REVISED RESPONSE TO REQUEST FOR ADDITIONAL INFORMATION

APR1400 Design Certification

Docket No. 52-046

RAI No.: 208-8245
SRP Section: 03.08.03 – Concrete and Steel Internal Structures of Steel or Concrete Containments
Application Section: 03.08.03
Date of RAI Issue: 09/14/2015

Figure 2. Line of Sight from Sparger

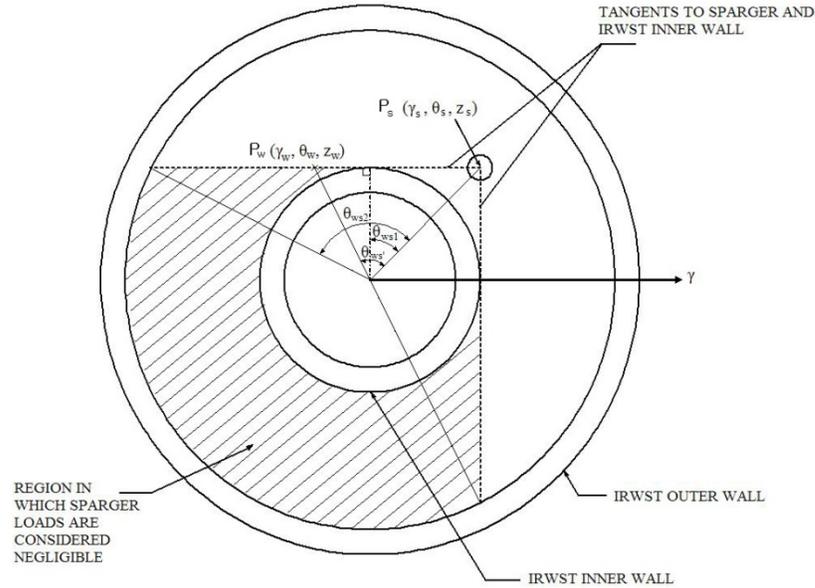
- c. How the total pressure transients on the walls and floor were developed based on the cases identified in item (b) above (a figure showing the pressure distributions on the walls and floor should be provided).
- d. How the dynamic impact factor, discussed in DCD Section 3.8A.1.4.3.1.3, was determined, and explain why applying this as a static load is considered conservative.

Using basic trigonometry, distance, r_{ws} , from the sparger center point $P_s (r_s, \theta_s, z_s)$ to the interested point $P_w (r_w, \theta_w, z_w)$ in Figure 2 is

Air bubble discharge loads from a particular sparger are considered to act only on the boundaries which can be "viewed" from the sparger bubble with direct line of sight as illustrated in Figure 2. To find the shade area, angle θ_{ws} on the line of the tangents to the sparger and inner wall can be expressed as

The shade regions between these two angles are not in direct line of sight of the depicted sparger discharge and, therefore, no load acts on these boundaries due to this sparger discharge.
